Customer	: CU-DAR001 Dart Helicopters Services	Drawing Name	: 350/355 AS X-TUBE FWD
Job Number	: 27826		
Estimate Number	: 12485		
P.O. Number	: N/A	Part Number	: D350748101
This Issue	: 7/5/2006	S.O. No.	: N/A
Prsht Rev.	: NC	Drawing Number	: IIN D350-748 P5 PREL <i>06.07.05</i>
First Issue	: N/A	Project Number	: N/A
Previous Run	: 27825	Drawing Revision	: PREL
	Type : LANDING GEAR	Material	: N/A
Written By	: <i>[Signature]</i>	Due Date	: 7/30/2006
Checked & Approved By	: <i>[Signature]</i> <i>06.07.05</i>	Qty:	1 Um: Each
Comment	: Est Rev: A New Issue 06-07-05 JLM

Drawing Name: 350/355 AS X-TUBE FWD

Part Number: D350748101

DESIGN 92	DRAWN BY	DART AEROSPACE LTD HAWKESBURY, ONTARIO, CANADA	
CHECKED	APPROVED	DRAWING NO. D350-748-141	REV. B SHEET 1 OF 3
DATE 06.06.30		TITLE CROSSTUBE (AS 350/355 HI FWD) SCALE NTS	
A	06.03.31	NEW ISSUE	
B	06.06.30	ADD D6017-115 & PRIME AND PAINT

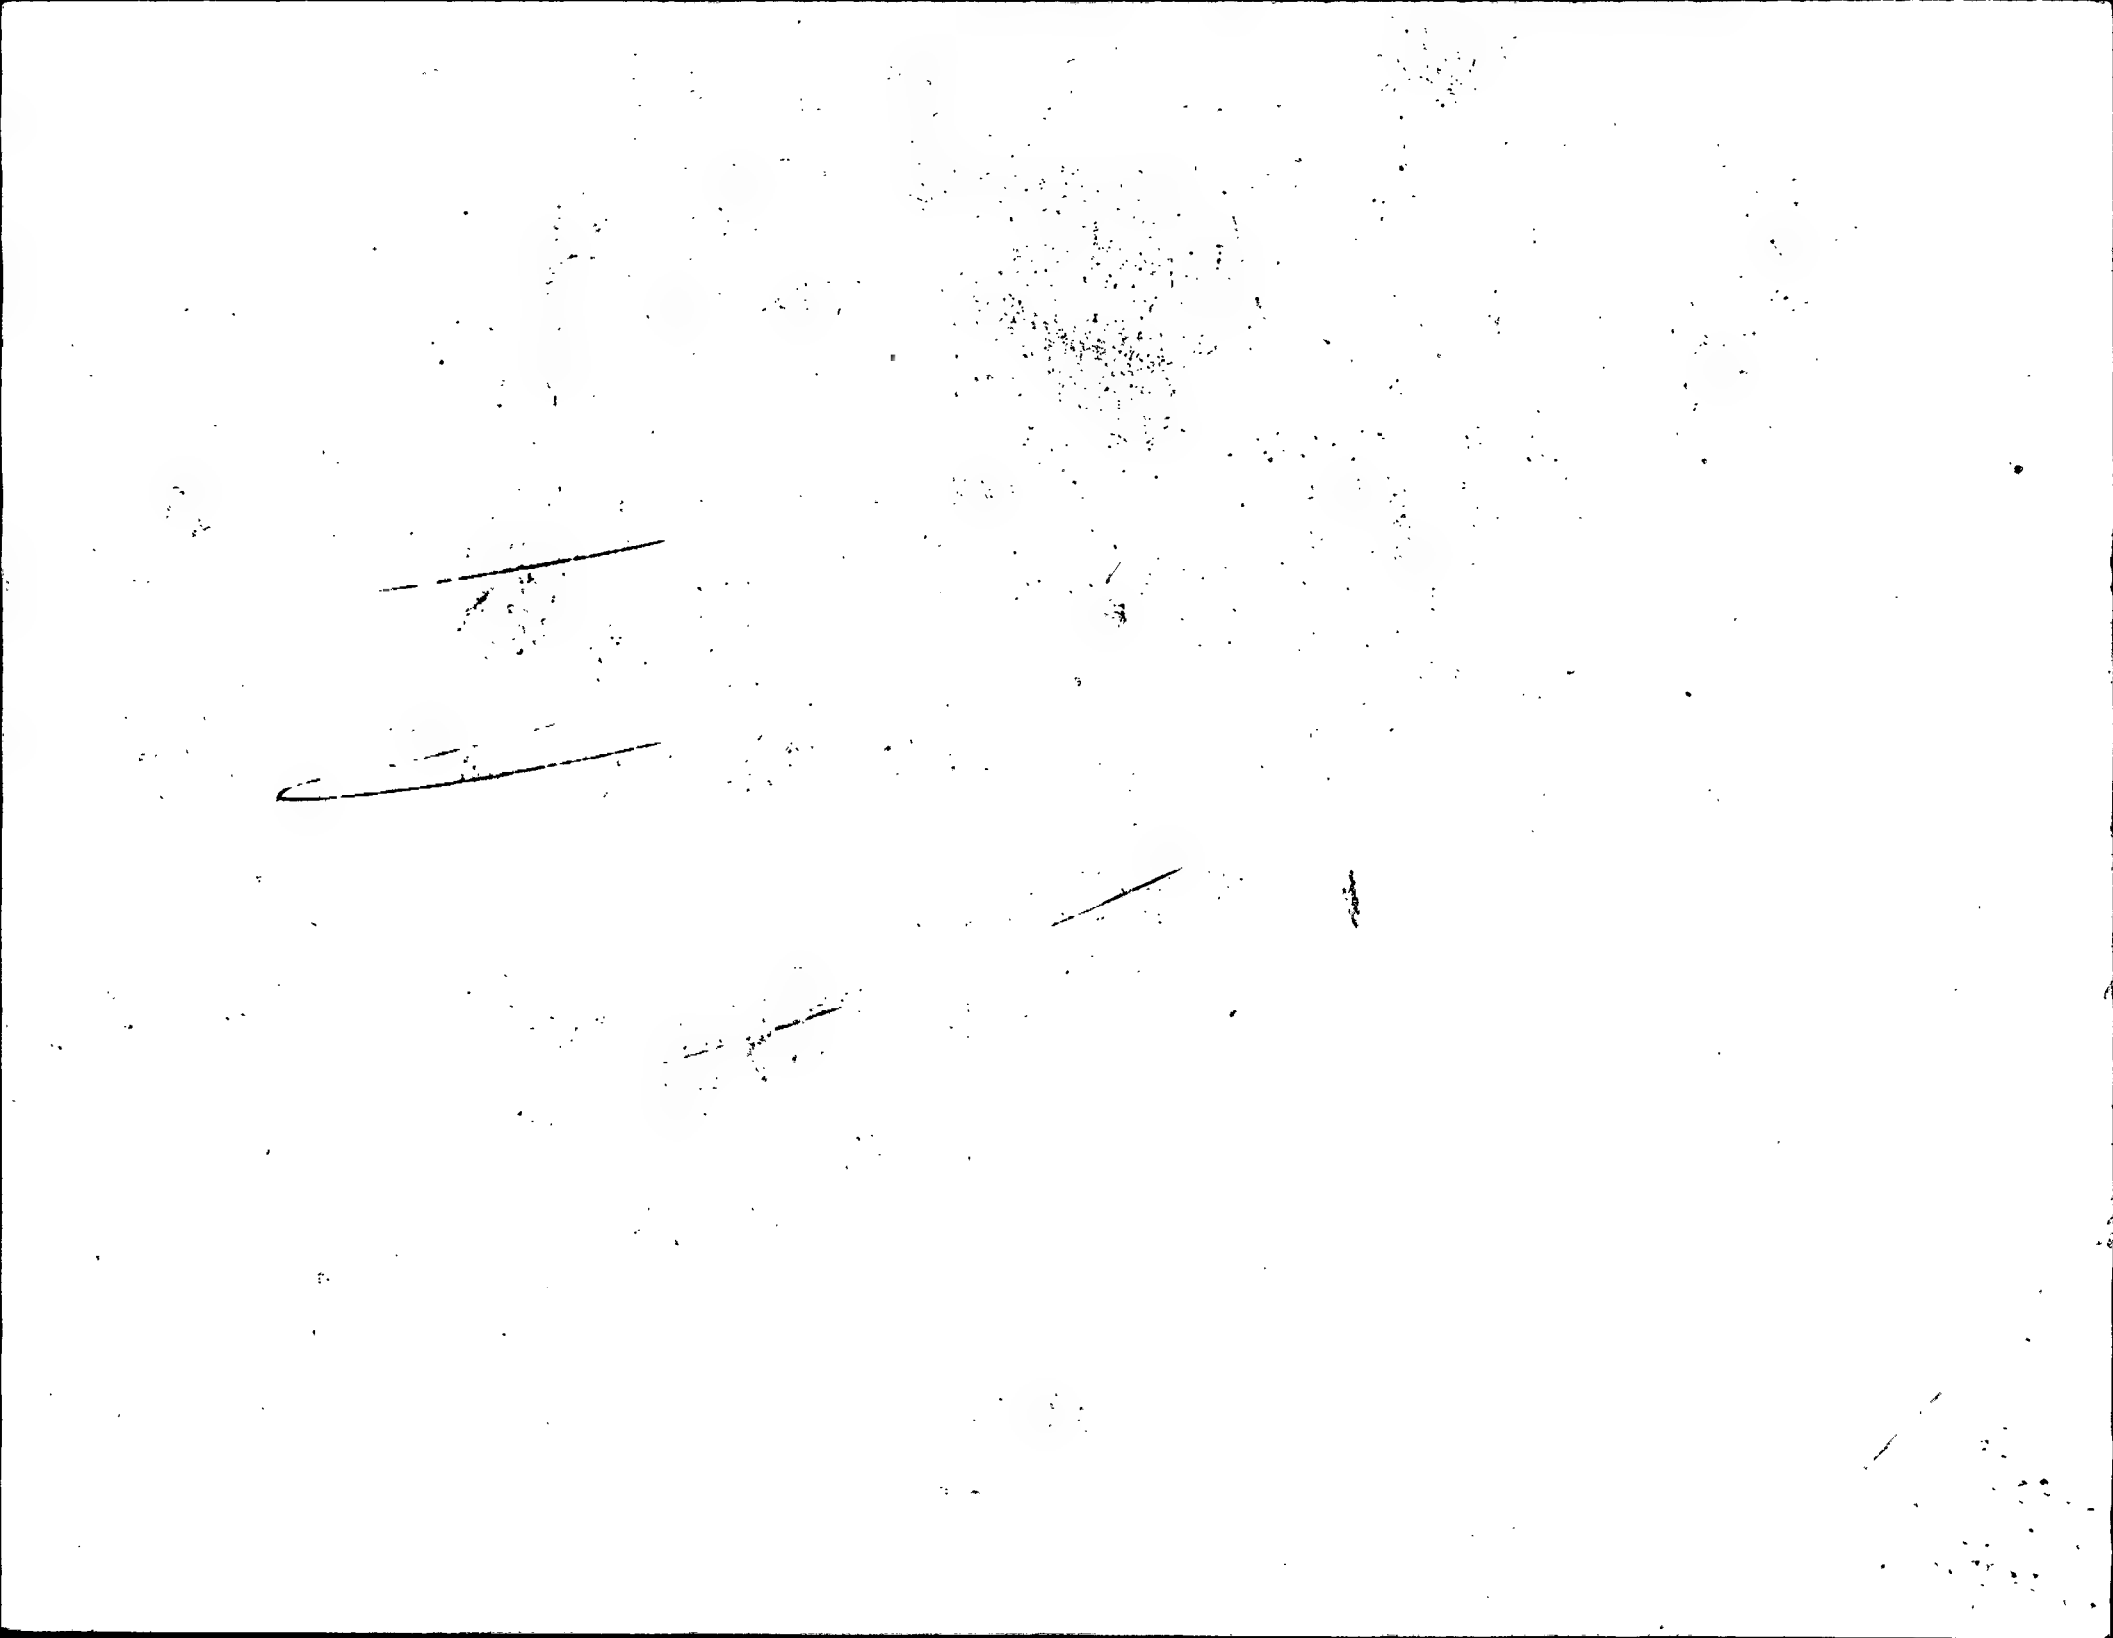
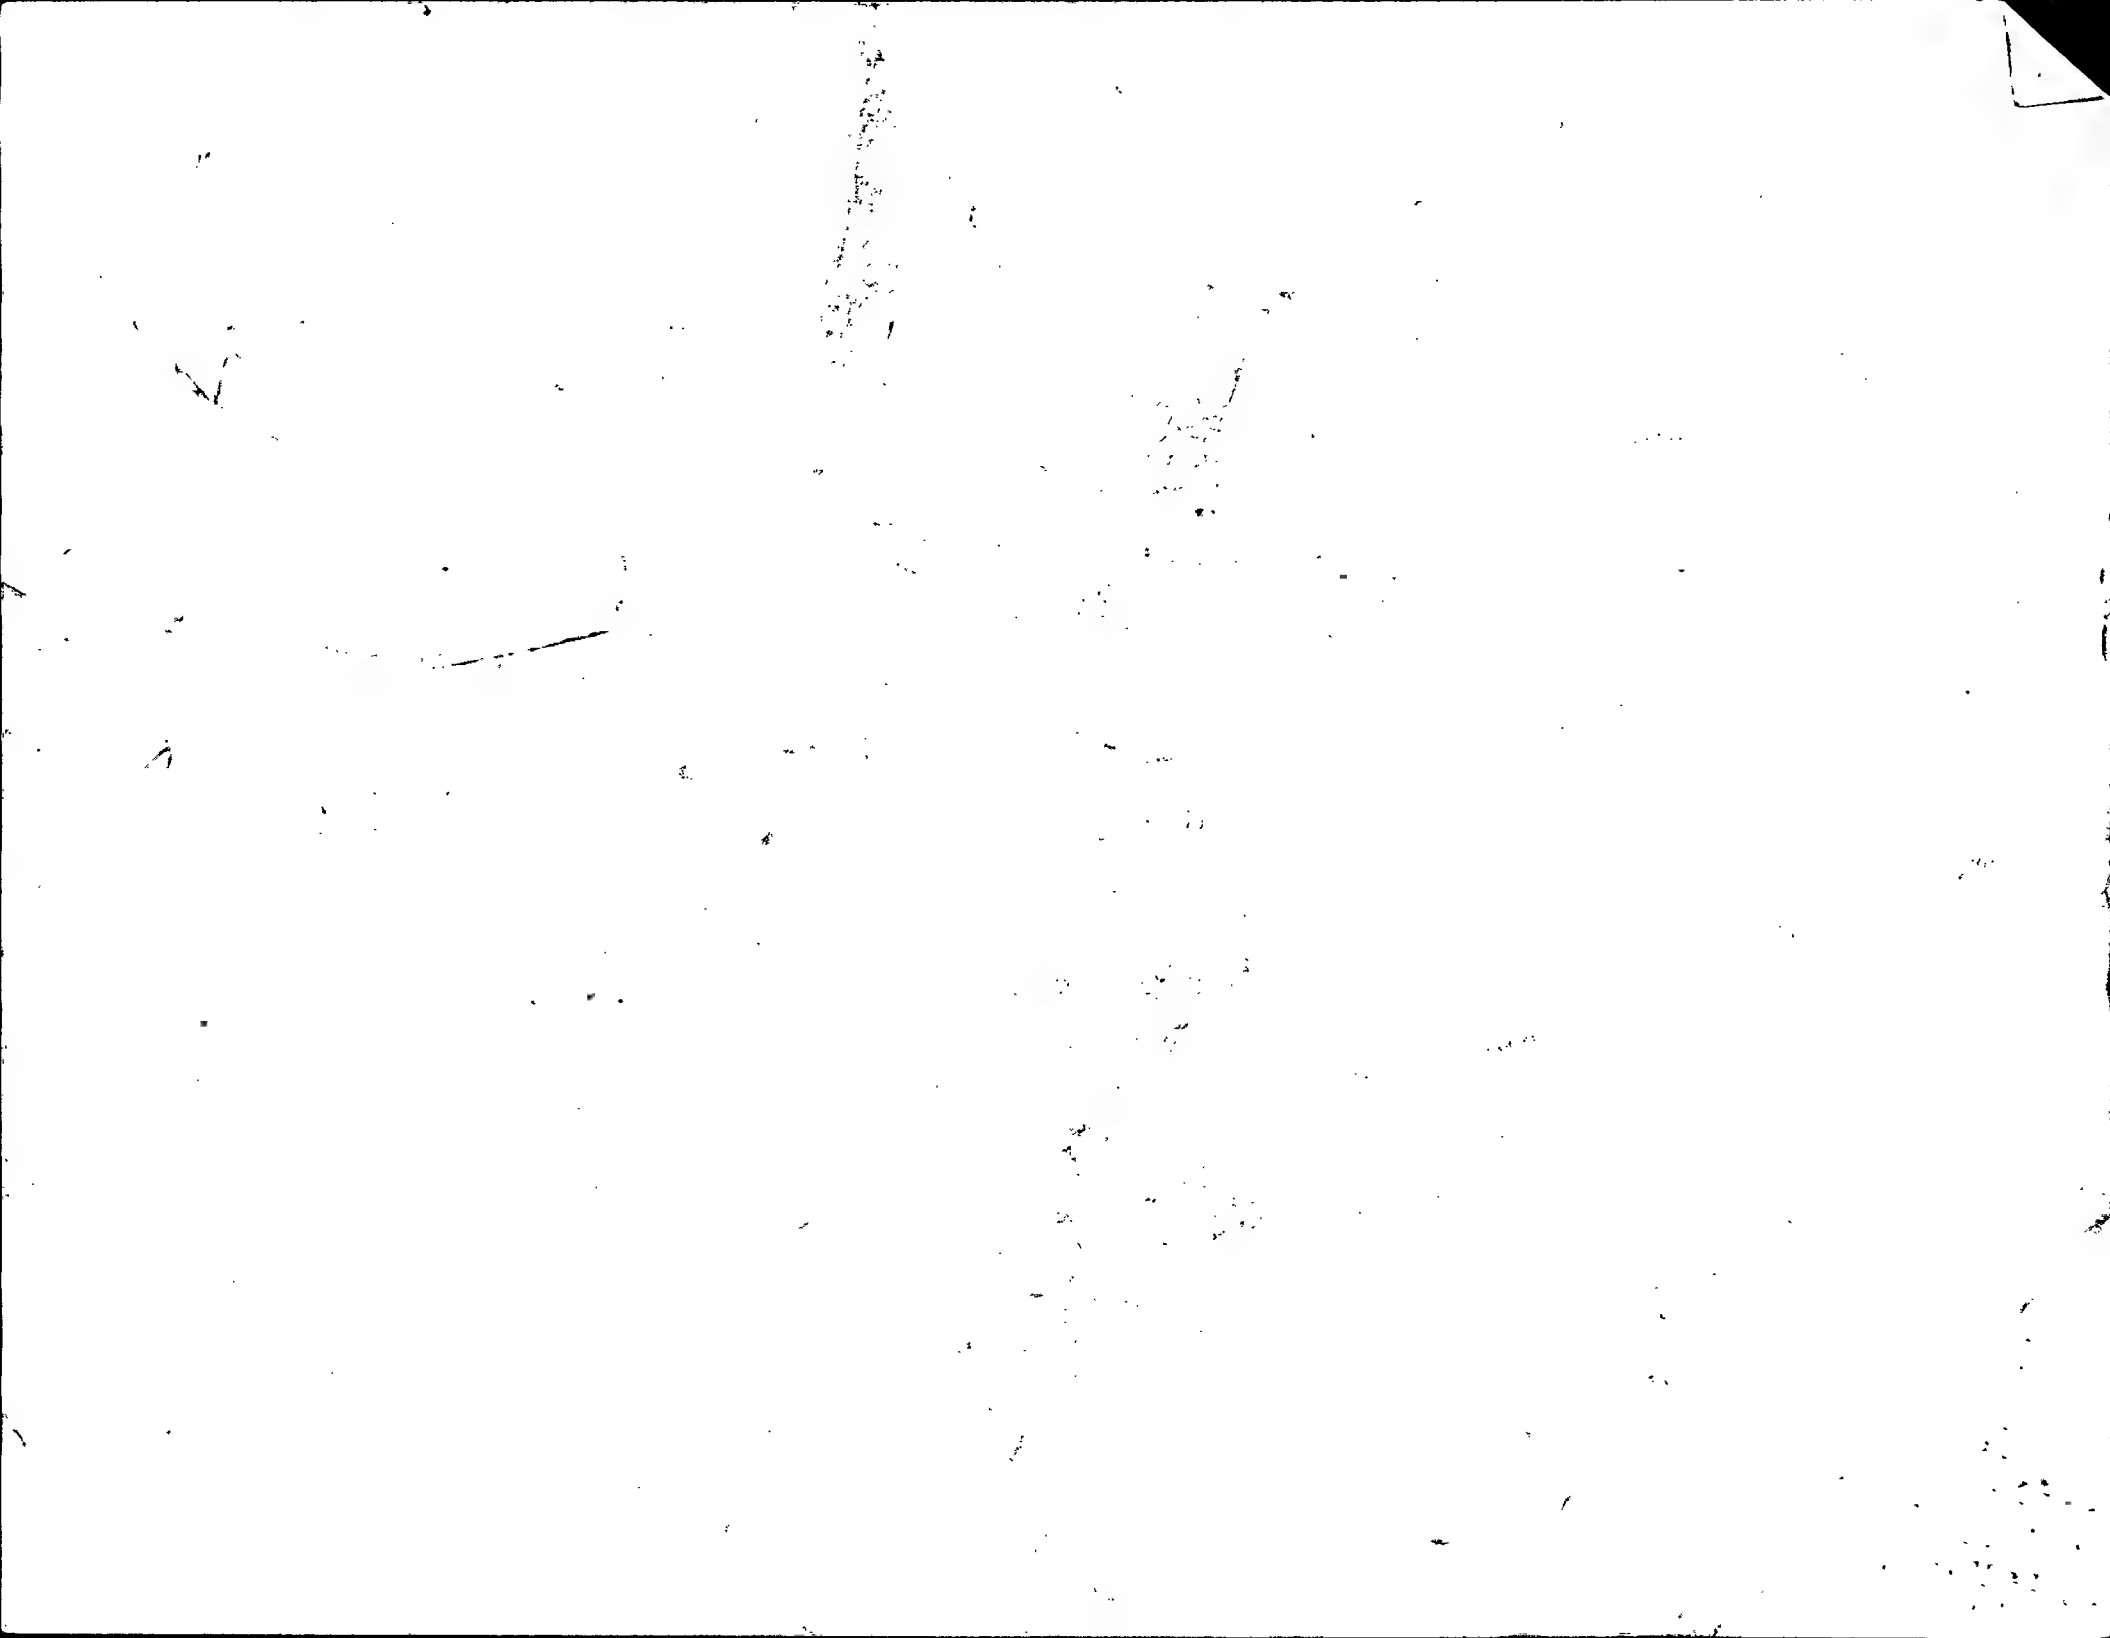
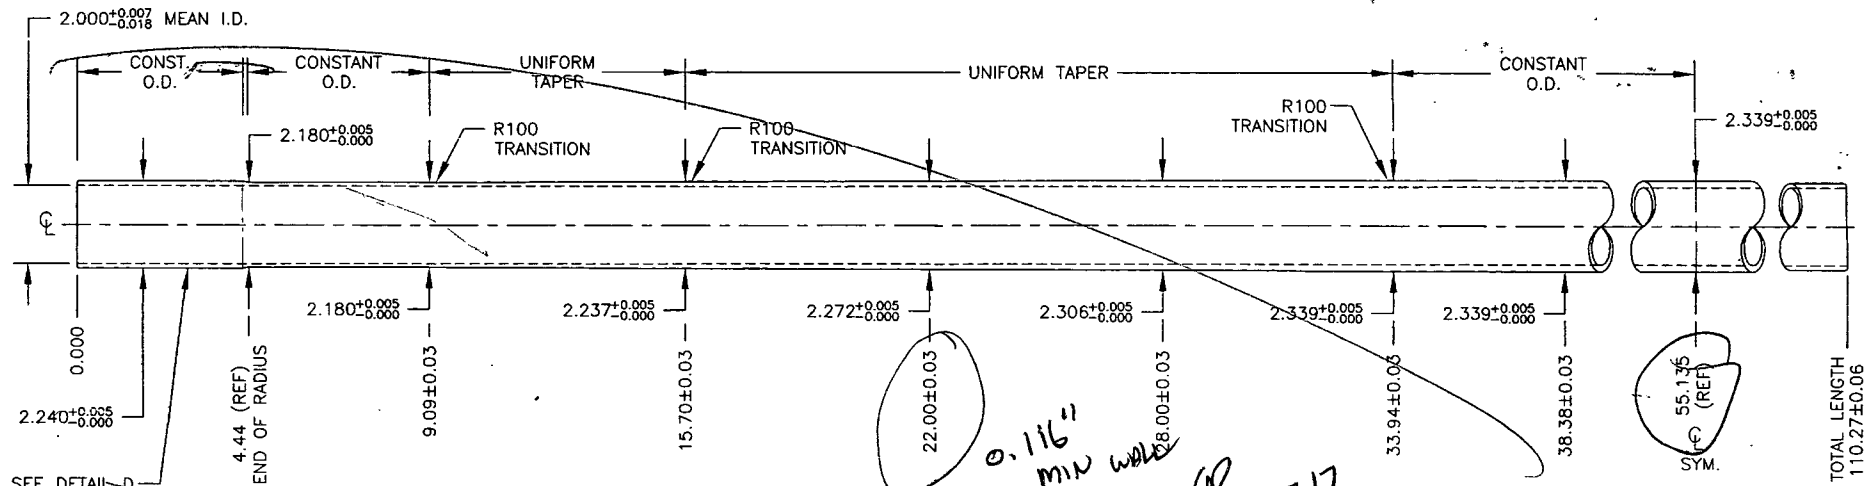
This is a different issue from the cad plating.

For one D350-748-141 crosstube, the hole for the grounding wire is 0.090" further inboard (towards the center of the crosstube). This crosstube was drilled by hand before they created their drill jig. The error was caught when they rechecked the crosstube to the tooling.

The only problem I see with this is the remote chance the grounding wire isn't long enough, which is more of a risk on Dart (potential return) and not a safety issue.

Acceptable deviation. There is no concern about the grounding wire. From what I saw, there is more than enough slack in the system.
